# NEWMAR CORPORATION WARRANTY DEPARTMENT

## TECHNICAL SERVICE BULLETIN

SERVICE BULLETIN

**SUBJECT:** Spartan Motors Chassis, Inc. has determined a defect relating to the modulator valves making contact with the IFS relay rod may exist in certain vehicles equipped with IFS2000 model front suspension.

**FIG. 3-1**

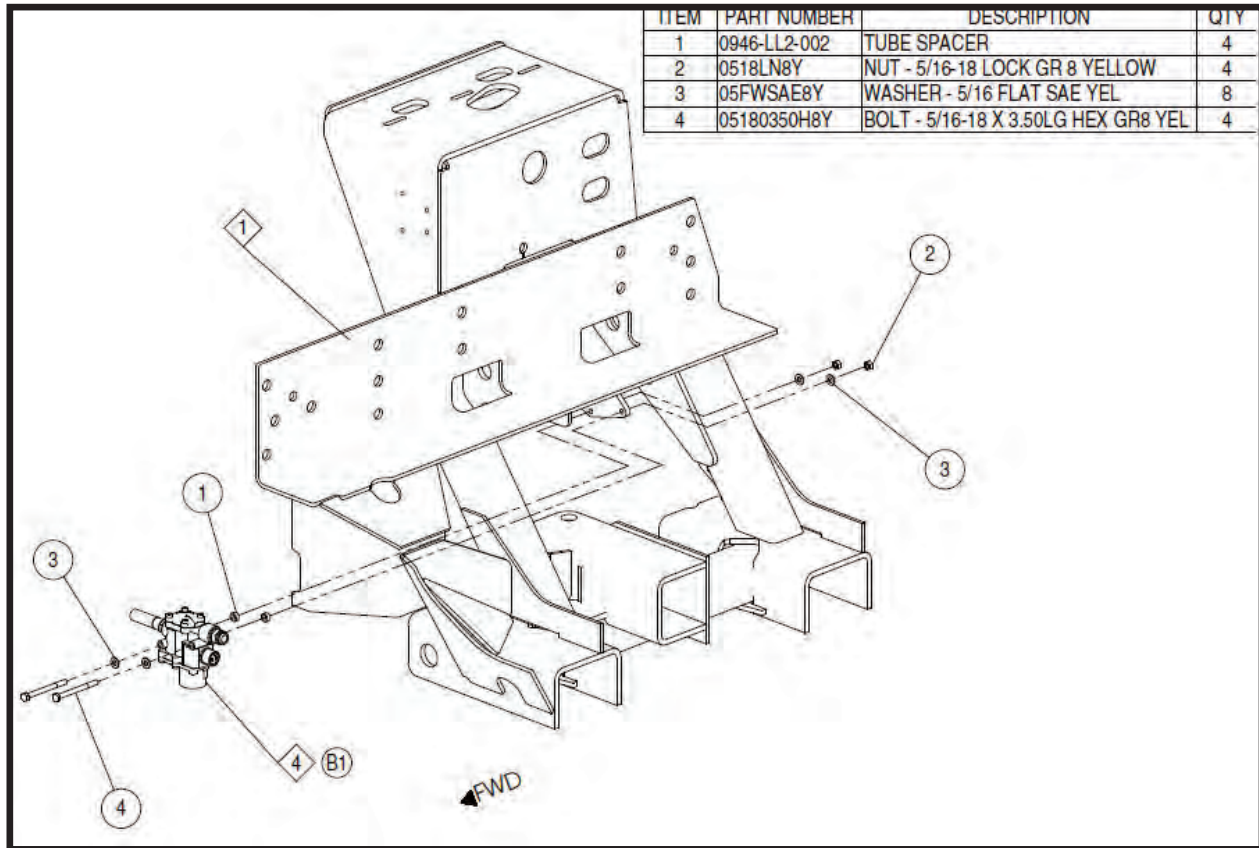
**CONDITION:** When the steering wheel is turned, the relay rod on the IFS may interfere with the ABS modulator valve.

**CORRECTION:** Add spacer behind ABS modulator valve.

2. Remove (2) 5/16 in. bolts, (4) washers, and (2) nuts that mount ABS modulator valve to suspension. Retain washers and nuts for reuse. Refer to FIG. 3-1.

3. Install spacers between ABS modulator valve & mounting plate. Refer to FIG. 3-1.
4. Install new bolts, retained washers, and retained nuts. Torque nut side to 15 lbs. ft.
5. Repeat steps 2 through 4 for opposite side.
